U.S. NUCLEAR REGULATORY COMMISSION  
REGION I

Report No. 50-336/89-13

Facility Name: Millstone Unit No. 2

Inspection: A special, announced team inspection to deal with multiple allegations was conducted from July 10 through July 21, 1989.

Figure C.3.41

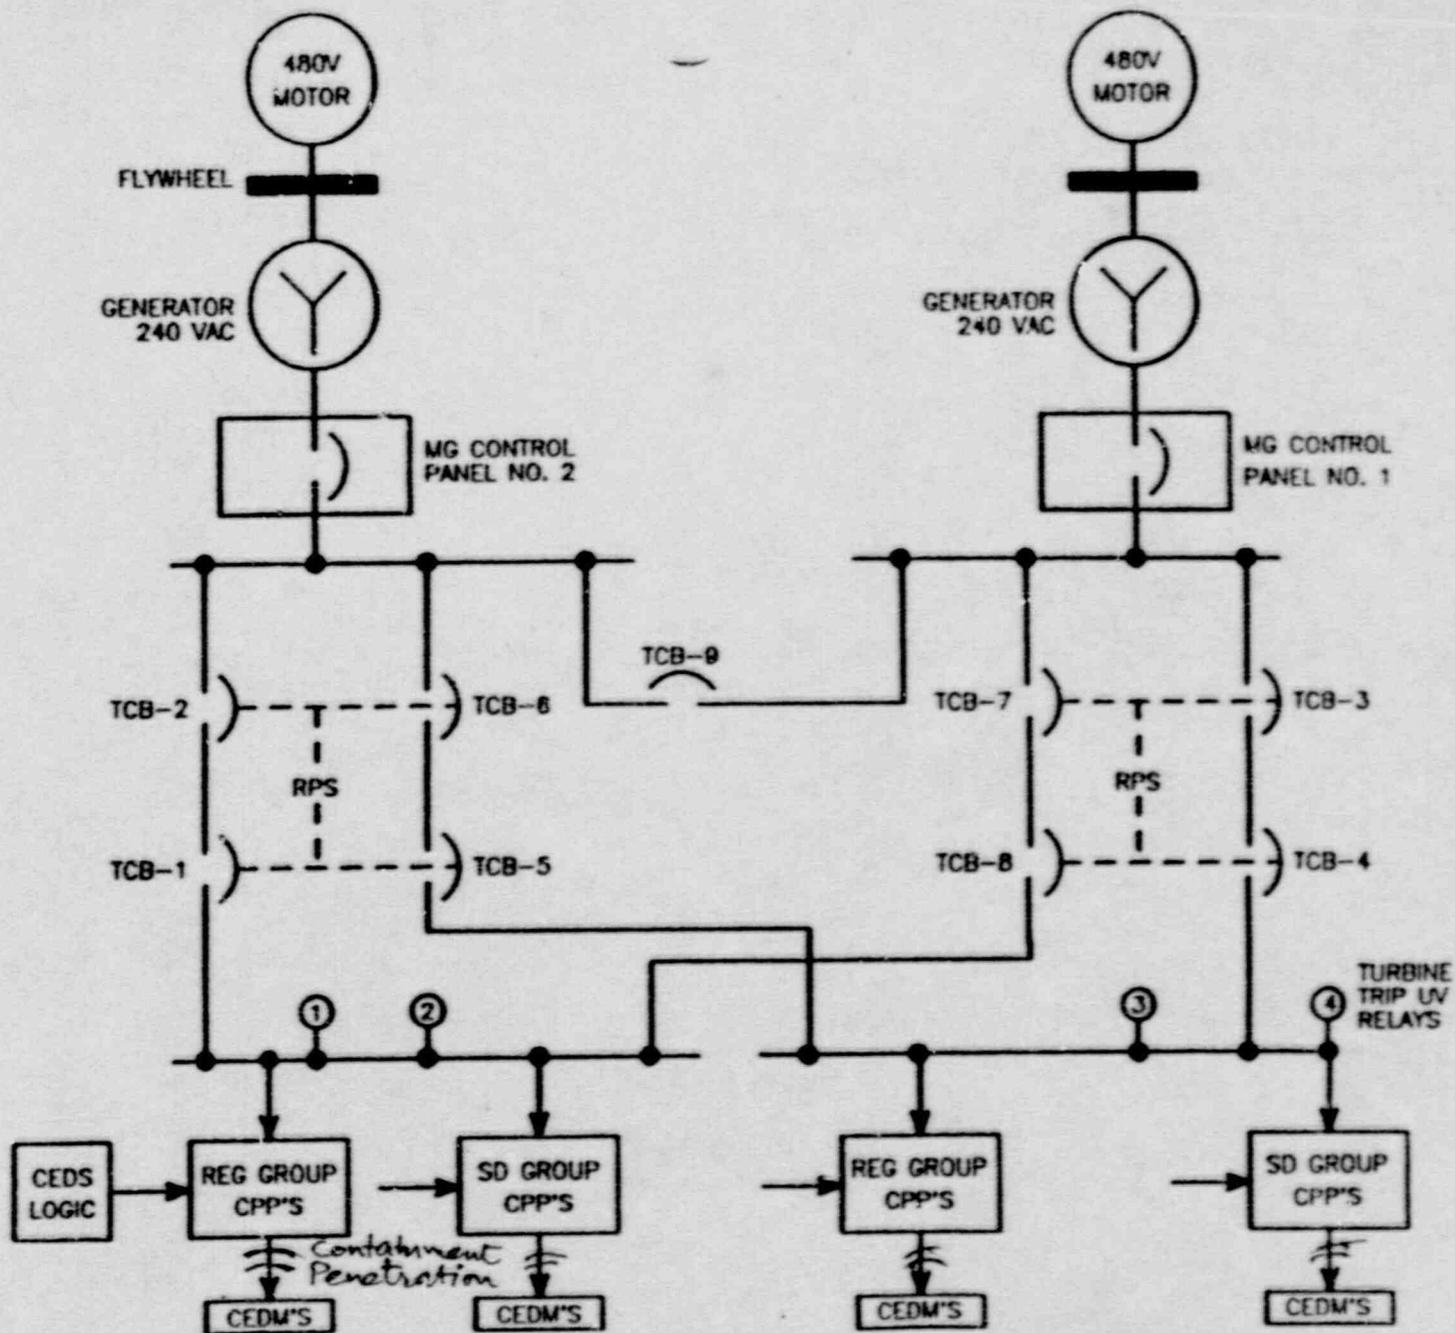
The 9 reactor trip breakers TCB-1 through TCB-9 are arranged as shown in Figure C.3.41. TCB-9 is a tie breaker, it does not perform a safety function. The safety function of a RTB is to open its contact on receipt of a reactor trip signal, thus interrupting the power supply to the control element drive mechanism (CEDM). This allows the control elements to drop into the reactor core, causing a reactor trip.

The circuit breakers are arranged in series such that if a breaker fails to trip the reactor when needed, the second can still trip the reactor. In addition, each breaker has two trip coils, an undervoltage (UV) trip coil and a shunt trip coil, to open the breaker contacts. When a reactor trip signal is received, the UV trip coil de-energizes to allow the contacts to open by spring

force stored in the breaker mechanism, in addition the shunt trip coil is energized to pull the contacts to the open position. These two trip coils work independently. Since "to-open" is the safety action, licensees are required to make every effort to assure the RTB will open when required.

In order to be conservative, the UV coil is calibrated at 106 VDC and at an ambient temperature of 68-77°F. An increase in temperature in the circuit breaker compartment will make the UV coil easier to trip, thus allowing the breaker contacts to open. During normal operation, the UV coil is continuously energized. This, plus electrical current through the contacts and cables, makes the circuit breaker compartment warmer than the switchgear room ambient. Even during the winter time, when the plant is operating the temperature of the circuit breaker compartment will not be lower than the setting temperature, i.e., 68-77°F. This assures that the UV coil will trip when required.

The inspector reviewed two high risk test reports, one dated April 20, 1989, and one dated April 28, 1989. In each of the tests, the 8 circuit breakers (TCB-1 through TCB-8) are required to open 6 times because of the matrix test requirement. The test results were tabulated on pages 14 and 15 of the test report, which indicated all 8 RTB's functioned properly.
